SERVICE BULLETIN

EQUIPMENT: RT-406F

BULLETIN NUMBER: WSB RT-406F-2

This modification consists of rework to the 300-012755 Synthesizer Logic Board (A10) assembly by applying Kapton tape to the specified location on the underside of the board.

Figure 1. RT-406F Synthesizer Logic Board

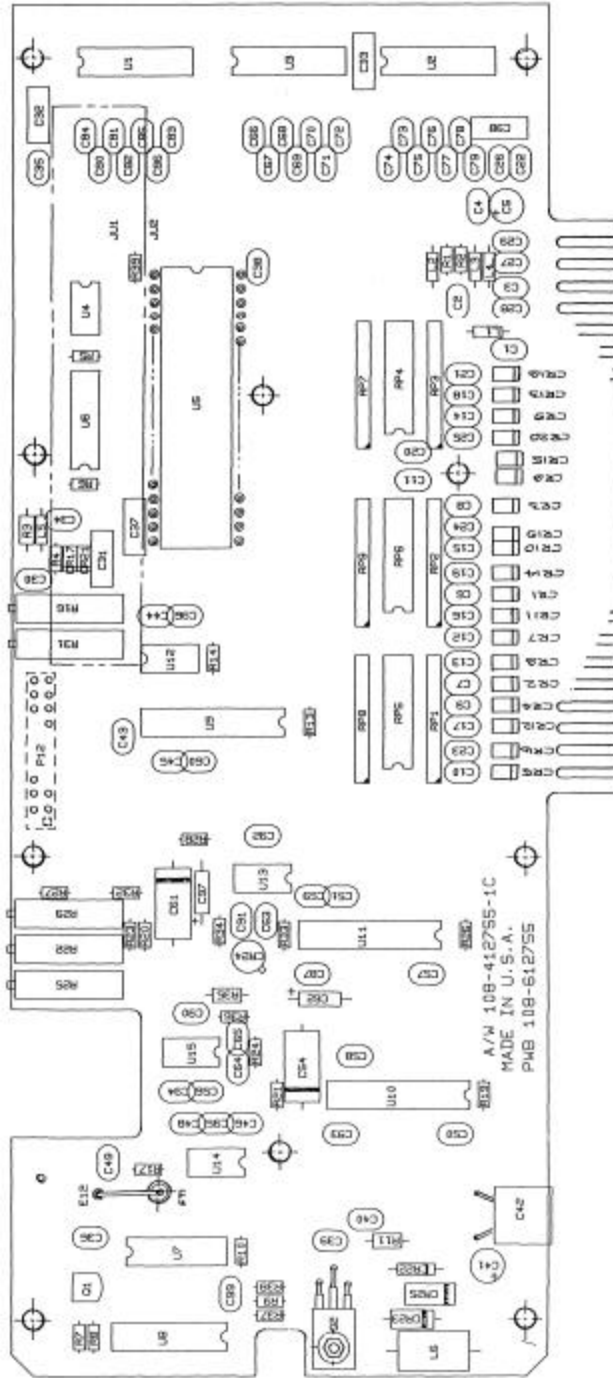
This procedure prevents the Synthesizer Logic Board mounting hole from wearing through to the PCB traces and shorting to the case.

1. Disassemble the RT-406F and remove the Synthesizer Logic Board in accordance with the procedure in Section 2.1 of the *RT-406F Maintenance Manual*, P/N 150-1332-000.
2. Apply a length of Kapton tape as shown in Figure 1.
3. Reinstall the board and reassemble the RT-406F.
